Your Comment on the Southland Wind Farm Project

1. Contact Details			
Please ensure that you have authority to comment on the application on behalf of those named on this form.			
Organisation name (if relevant)	West Catlins Preservation Society		
*First name	Natalie		
*Last name	McRae		
Postal address	[REDACTED]		
*Home phone / Mobile phone	[REDACTED]	*Work phone	[REDACTED]
*Email (a valid email address enables us to communicate efficiently with you)	[REDACTED]

TO PRESERVE AND ENHANCE THE WEST
CATLINS AREA ENSURING A VOICE IN THE
DEVELOPMENT OF OUR REGION

F.2 Continued Welcome to the Catlins Conservation Park will have the towers in image E above notably visible. House pictured in image E is this house in F.1 above and F.2

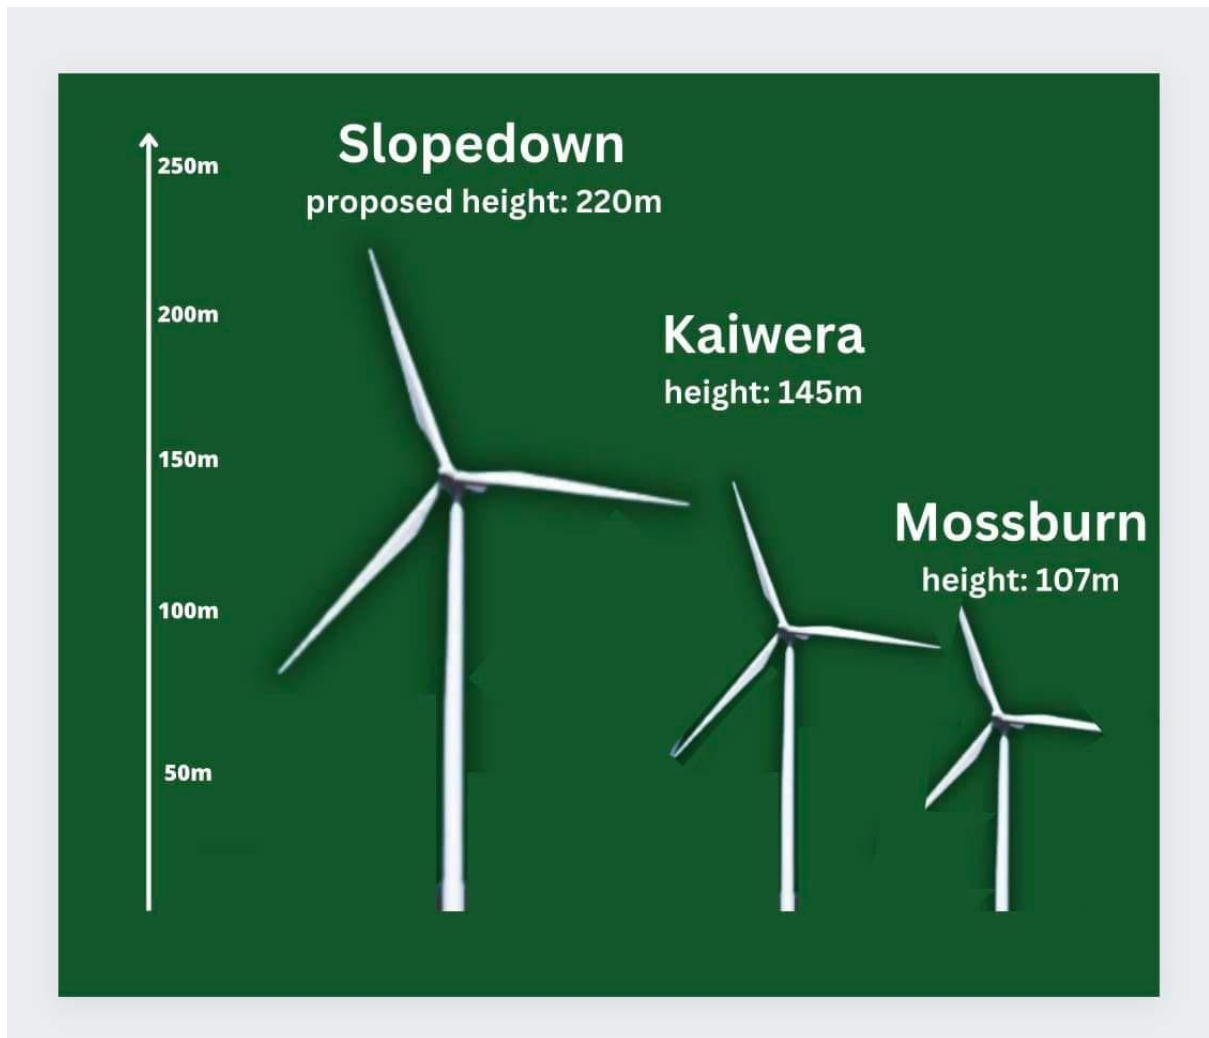
F.1 Welcome to the Catlins Conservation Park will have the towers in image E above notably visible. House pictured in image E is this house in F.1 and F.2 below.
